Delegated Report

Application No: 20240602

Location: The Old Parsonage, Butchers Hill, Shorne DA12 3EB

Description: Application for approval of condition 3, 4, 6, 7, 9, 10, 11 and 12 attached to listed building consent reference number 20220275 relating to details at a scale of 1:10 & 1:5 as appropriate, of the proposed interface between the existing buildings and the new buildings (3), Details of their design, specification, method of opening, method of fixing and finish, in the form of drawings and sections of no less than 1:10 scale, and ½ or full size (4), Details of their design, specification, method of opening, method of fixing and finish, in the form of drawings and sections of no less than 1:10 scale, and ½ or full size, including the manufacturers details (6), samples and detailed specifications of all external materials to be used on the works (7), details of the finishing treatment of the and eaves (9), details of the treatment of verges and eaves (10), samples or detailed specifications of the rainwater goods (11) and full details of the siting, appearance and materials to be used in the construction of all extractor vents, heater flues, meter boxes, airbricks, soil

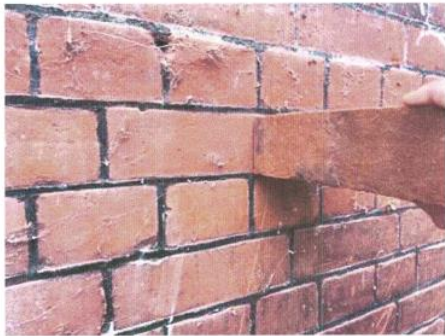
Rubbed brick arch details, junction between the orangery and main house and between the kitchen and house are submitted. The brick arch is shown below:

The submitted details are acceptable and this condition can be discharged.

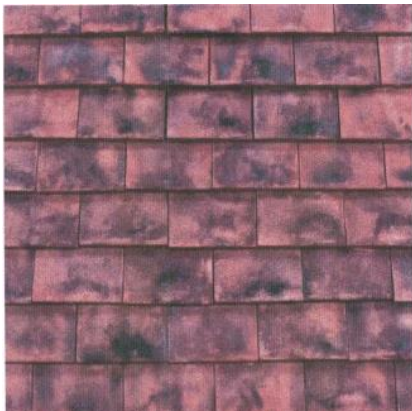
The kitchen extension roof will be tiled with the Goxhill Restoration Blend roof tile shown below:

The proposed materials are acceptable and this condition can be discharged.
